File: DP 24-046836

Re: **Application by Interface Architecture Inc. for a Development Permit at 5471, 5491/5493, 5531, 5551, 5571, 5591, 5595 and 5611/5613 Steveston Highway**

Staff Report

4 COVERED MAILBOX DETAIL
SCALE: NTS

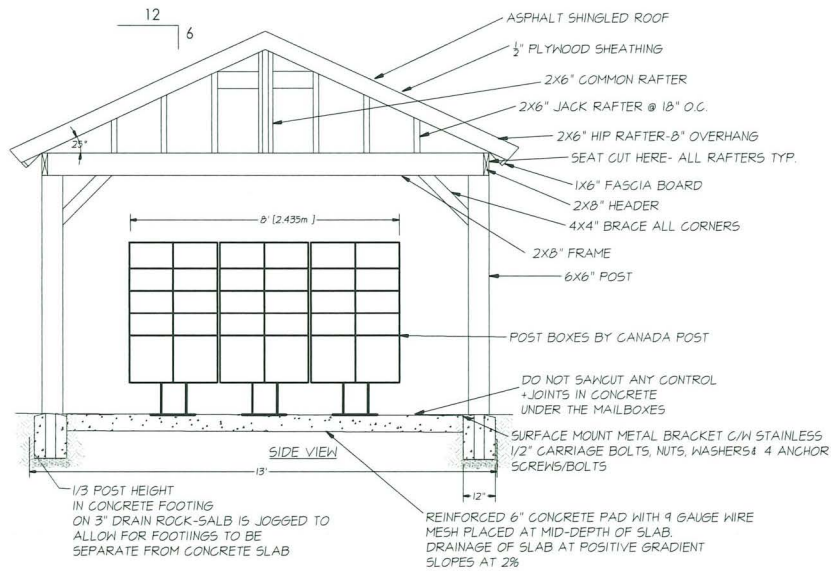
- clarify whether a hip roof or gable roof will be used for the covered mailbox area; the landscape drawings show a hip roof, but it appears to be a gable roof in elevation; the mailbox area should better reflect the character of the residential architecture;

The mailbox cover is a square hip roof design; elevation drawing is correct as the structure is square. It will be painted gray to match the architectural trim and the frontage wood picket fencing.
